## Memorandum

Subject: Preliminary Plat – Talus Parcels 7-9  
File No: PP14-00001

***ARE TALL WALLS IN ALIGNMENT WITH TALUS GOALS AND GUIDELINES?***

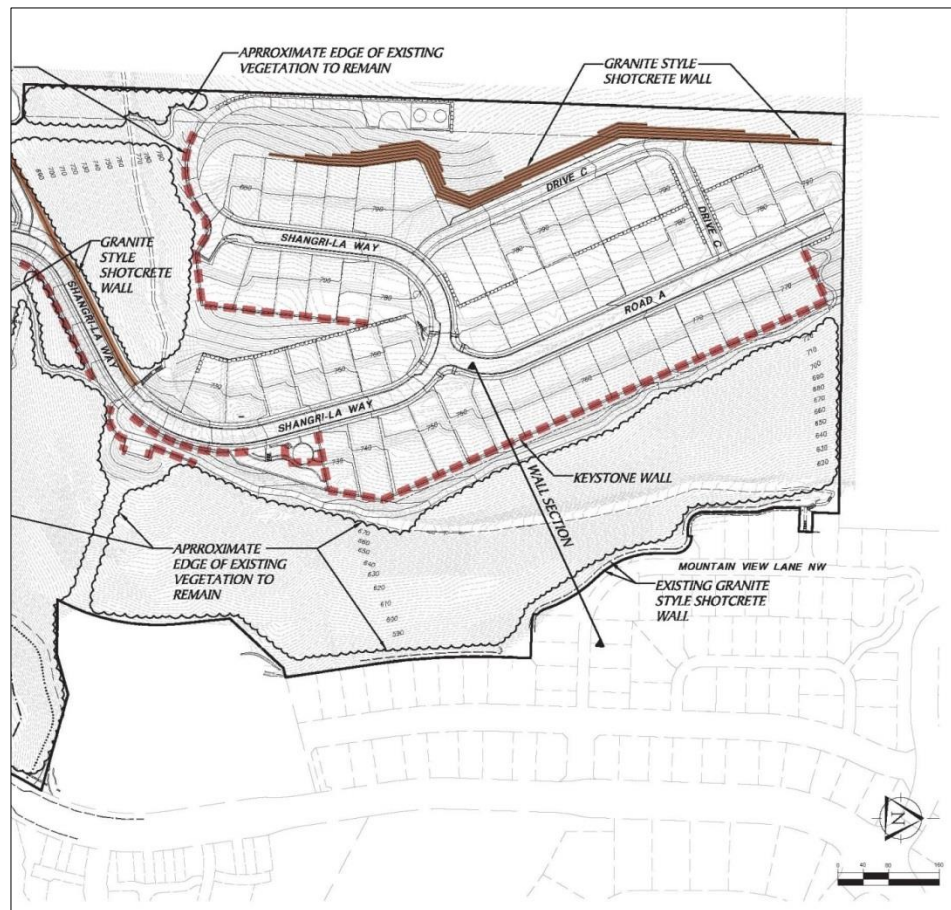
**Issues:** Tall walls do not seem in line with the Talus Goals or Guidelines.  
Who will maintain the walls?  
Will the walls be able to hold up hill?  
Walls should be built so that they are not climbable.  
How will trees planted adjacent to walls affect wall integrity?

***Tall and long walls do not seem in line with the Talus Goals or Guidelines.***

The Mountain Village character of development results in parcels which are separated by open space areas. In a mountainous terrain this will require the use of walls to preserve open space areas while making efficient use of the land. “4.0 General Community Goals, Goal 1 excerpts; The Urban Village is defined by.. discernible edges, efficient utilization of land and accessible open space...” “Talus will be an urban village adapted to reflect the mountainous terrain of the site. The result will be an urban village with a mountain village character. Generally this means development that conforms to the topography of Cougar Mountain, provides large areas of open space, relates the built environment to this open space...”

### ***Who will own and maintain roads?***

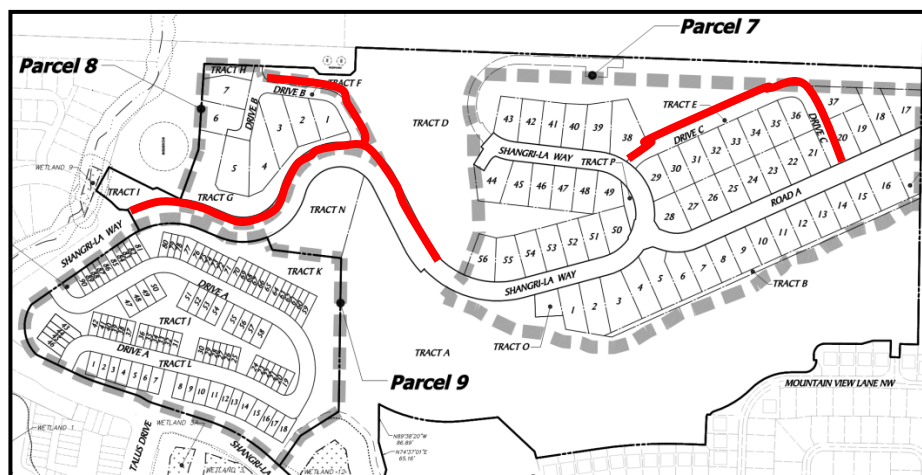
**Issues:** Do the roads have sufficient capacity to handle 153 new residential lots?  
Why are dead end streets being proposed/allowed?  
Who will own and maintain the roads?

All roads within the plat are proposed to be privately owned with the exception of Shangri-La Way and Road A (Parcel 7). Public roads will be maintained by the City and private roads will be maintained by the Home Owner's Association (or other entity as determined with the final plat).

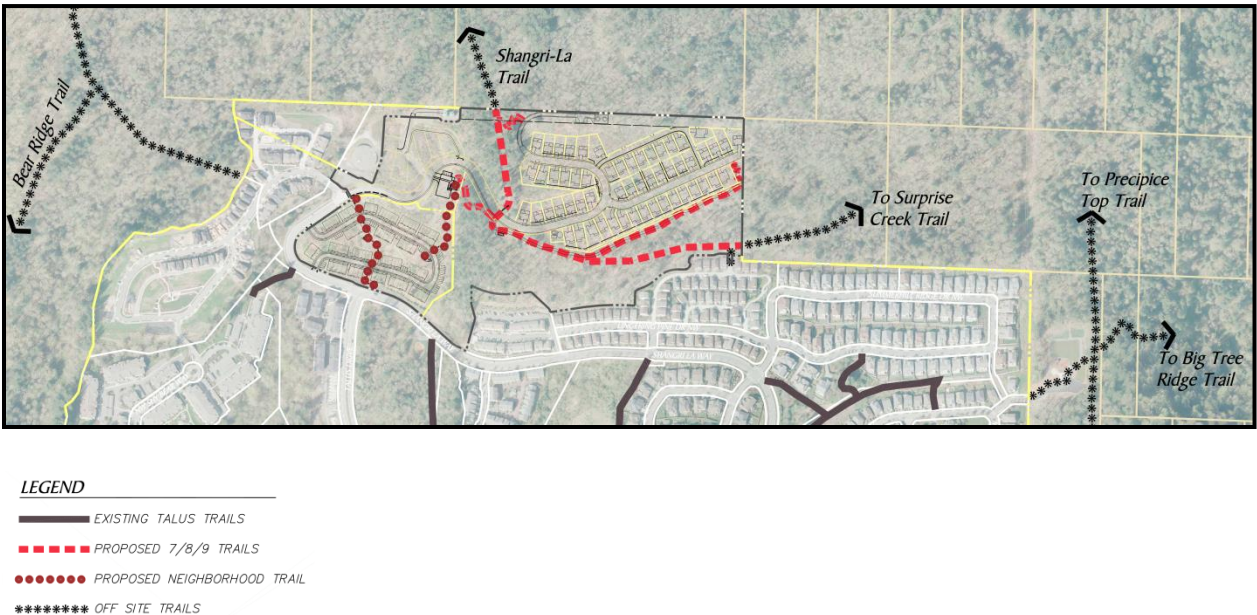
**Issues:** Will trails outside of Talus be brought up to standard?  
Who will own and maintain the trails? Is public access allowed on the trails?  
How will steps in trails be constructed? Some existing steps are not holding up very well.  
How/when will community be informed if trails are being close due to construction?  
What trail types are proposed for the various trails in the plat?  
How many new feet of trails will be constructed?  
Will trail wayfinding signage be included with the trails?

Staff: Trails outside of Talus are outside of this preliminary plat and are not owned by the applicant or the City. Neither the applicant nor the City has the authority or permission to modify the trails outside of the boundaries of the application.

Trails, either existing or proposed trails, will be provided within the proposed open space tracts. These tracts will include language on the final plat to allow public access to the trails located within these private tracts. As noted above, the tracts are proposed to be owned and the trails will be maintained by the Talus Home Owner's Association.

Details regarding step construction have not been finalized with the applicant. As provided in their presentation, it appears that a constructed step with wooden timbers and gravel could be proposed for the trails. This design is generally consistent with the Appendix Q (Landscaping) construction details for Timber Stairs and Timber Stair Landings. The final design of the stairs will be verified with the construction permits for compliance with the standard. Other stair design alternatives acceptable to the City and the HOA may be considered.

Two types of regulated trails, as provided for by Appendix R, are proposed. Firstly, Neighborhood Trails are proposed for the hillclimb in Parcel 9; and, for the trail connecting Parcel 9's north side to the recreational facilities in Tract N. Neighborhood Trails are generally a hard surface. The remaining trails within the plat are the Forest Path type and feature a soft surface (usually a coarse mulch or wood chips). The tread width of the Forest Path trail is 4 feet with an additional 8 feet provided for the trail corridor. It is anticipated that the proposed trail types and locations are provided in the map below.
